SEWAGE DISPOSAL SYSTEM

HOWARD COUNTY HEALTH DEPARTMENT
BUREAU OF ENVIRONMENTAL HEALTH
464-9583 313-2640

ADDRESS 10627 Breezewood Drive, Woodstock, Maryland PHONE _____

SUBDIVISION Breezewood Farms LOT 5, Sec. 1 ROAD 10627 Breezewood Drive

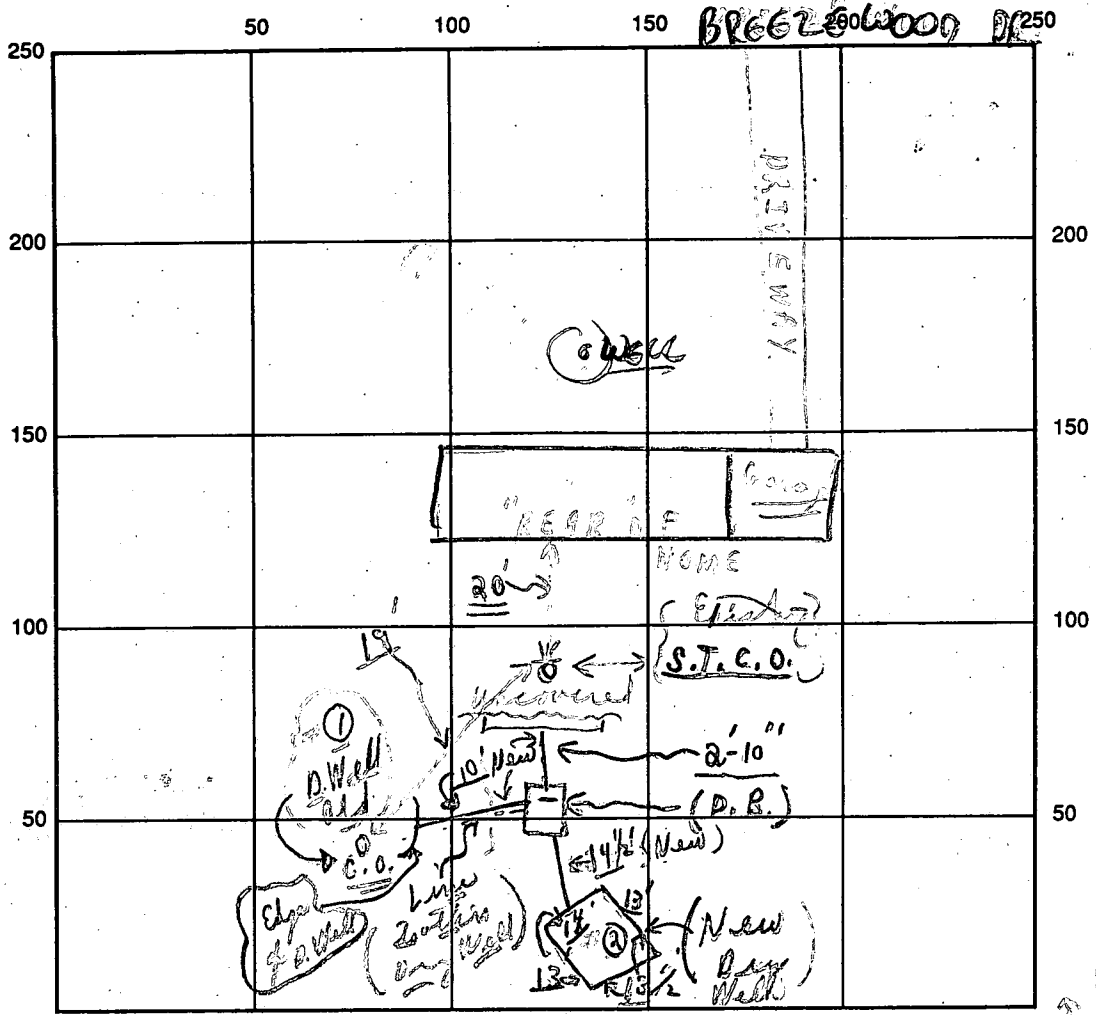
SPACE LIMITED - DRYWELL MAY BE BEST REPAIR OPTION - MR [Signature]

3/29 - as per above -> C.B. - Dig well on with 13' x 13' square hole; 8' under pipe inlet. Inlet 4' to 4 1/2' below ground makes as shown on back - Make depth 13' for dry well. C.B. for "C.W."

SEPTIC TANK LEVEL Existing CLEANOUTS (3) New C.O. ok
 DISTRIBUTION BOX LEVEL (Baffling) OK New - 3'± from S.T. (See above)
 DRAIN FIELD/TITLE DEPTH FT. TRENCH WIDTH FT. INLET DEPTH 4 1/2 FT.
 EFFECTIVE GRAVEL DEPTH FT. TOTAL LENGTH FT.
 NUMBER OF TRENCHES ONE SIDEWALL/BOTTOM AREA SQ. FT.
 DRYWALL INSIDE DIAMETER 52 FT. EFFECTIVE DEPTH BELOW INLET 8 FT.
 ABSORBENT AREA 416 SQ. FT. (plus OLD SYSTEM)

REMARKS: 3/29/93 ok to start on repairs & call when
ready for inspection. C. Bd.
3/31/93 P.M. - all done except C.O. Top; final-material
on site) to finish job. C. Bd

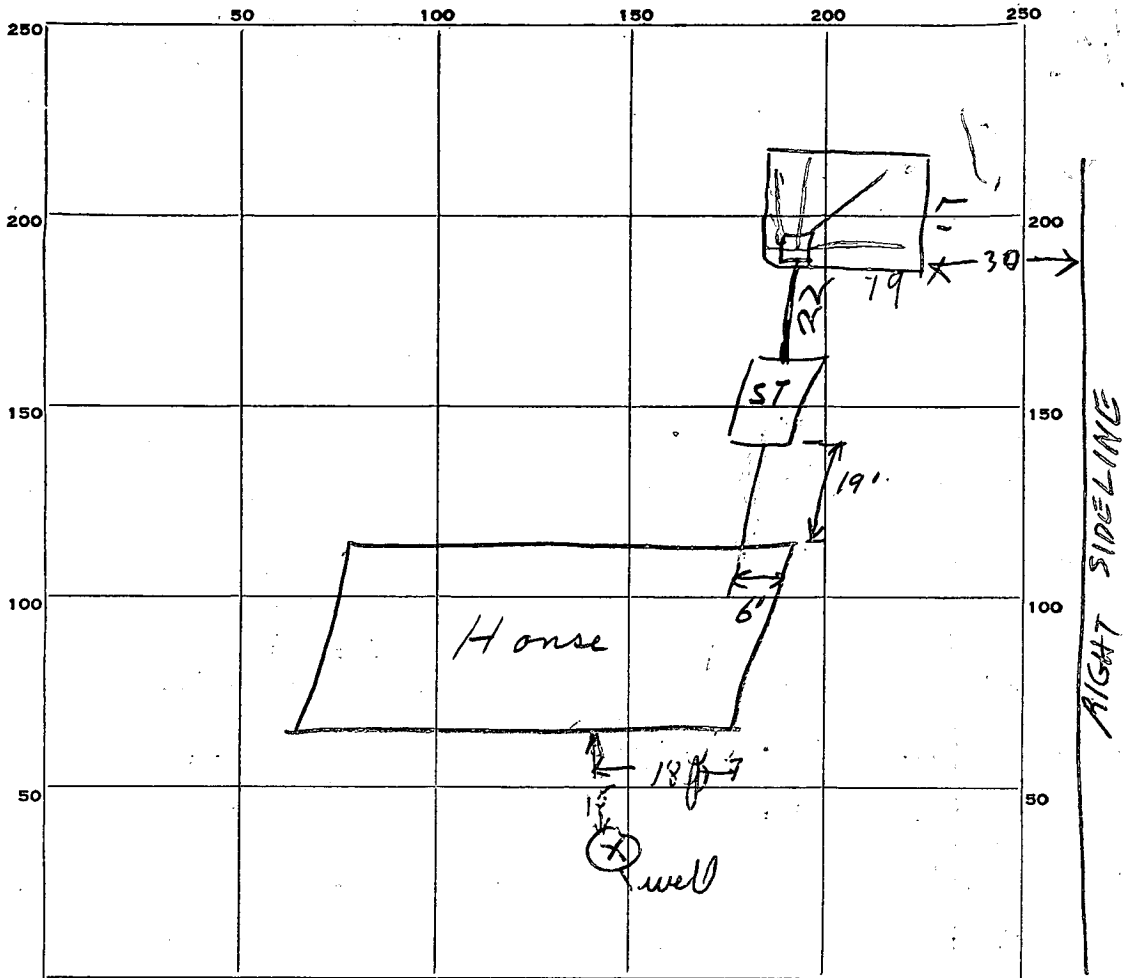
REMARKS 11/20/64 - to back where leaching bed is to go it appears that leaching bed bottom will have to be about 9ft. below original grade - Mr. Leonard will dig out place for leaching bed at depth it will go and then call for test at that depth. Will also need test 4ft. below that depth. R.F. (Advised to cover septic tank)

4" perma flow ^{plastic} sewer pipe from tank to Bed

11/24/64 - 300 sq. ft. bottom area at depth of 9 ft below grade
including gravel bottom. Center of bed to be 4.3 ft from right
side line and 32 ft from rear of Septic Tank

SITE PLAN
 SCALE: 1"=40'

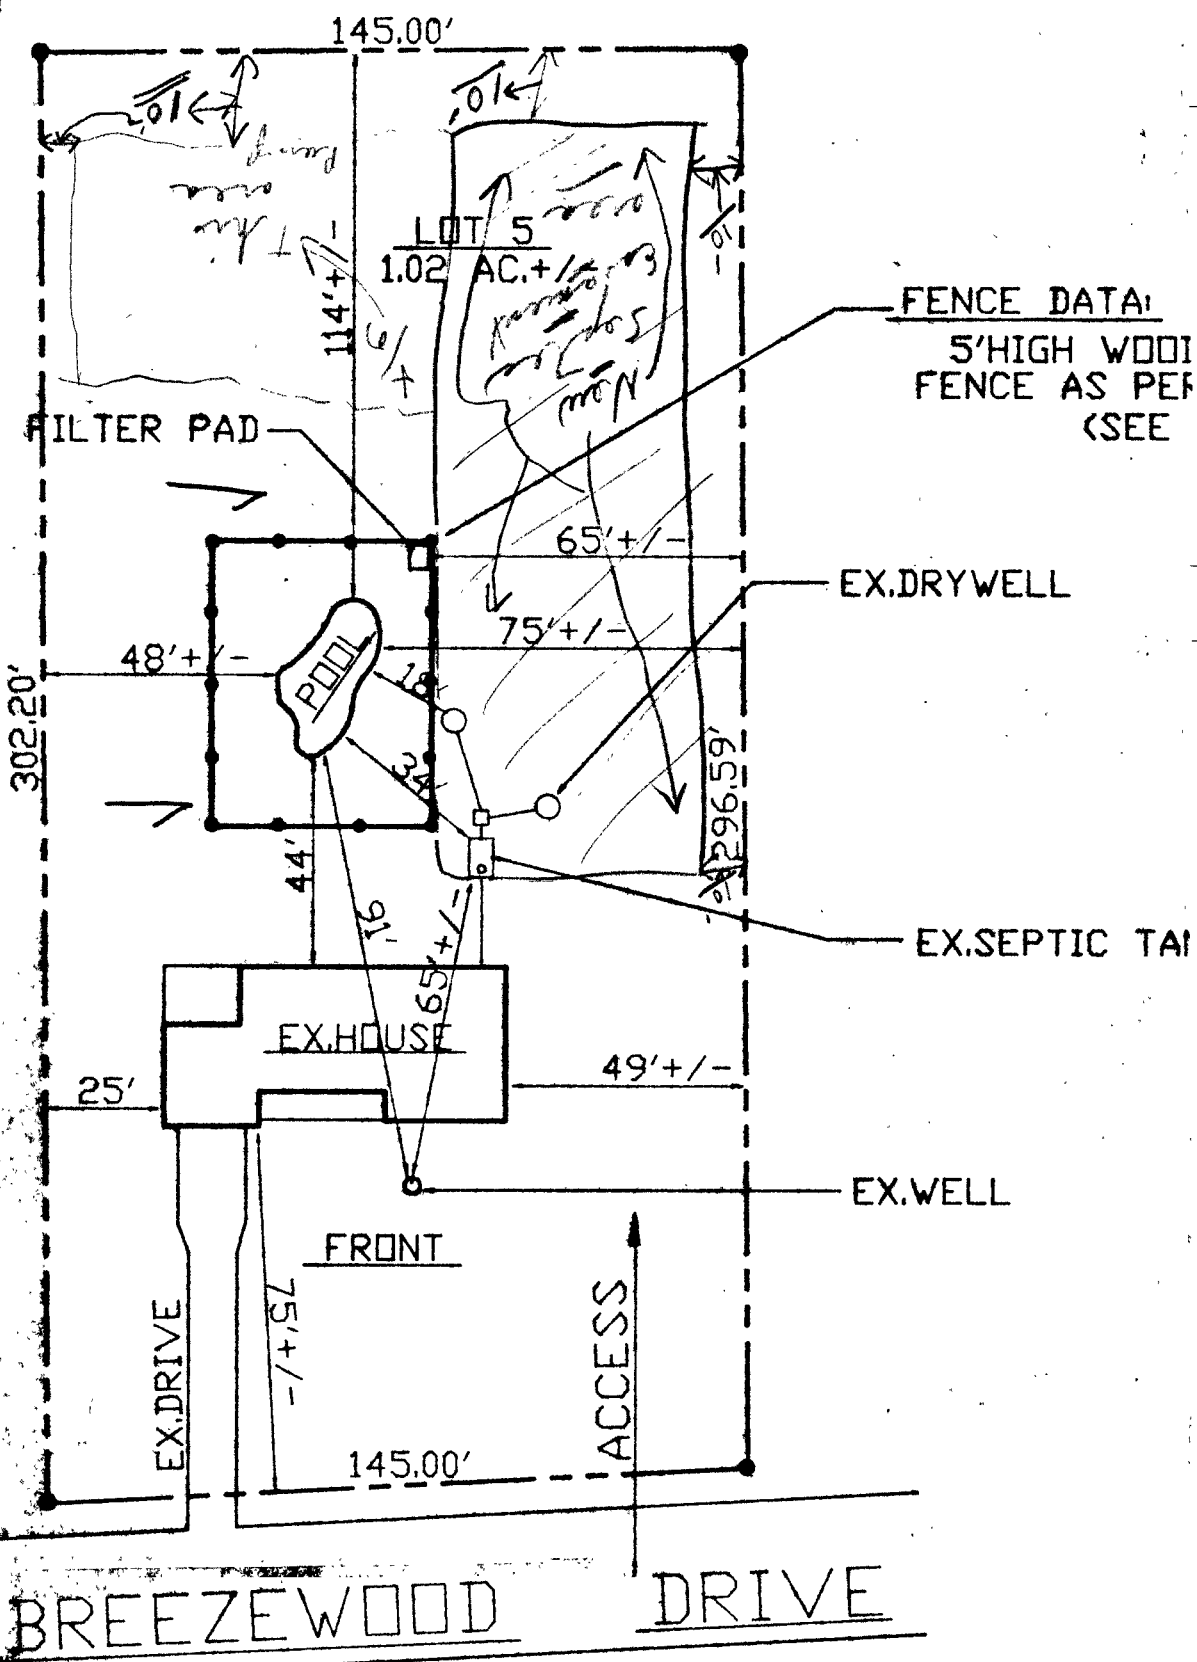
SETBACKS:	
REAR PL.	10'
SIDE PL.	30'
HOUSE	10'
SEPTIC	20'
WELL	10'

PRIVATE WELL & SEPTIC as shown
ok CBS
 For pool # 55765
 7/14/94
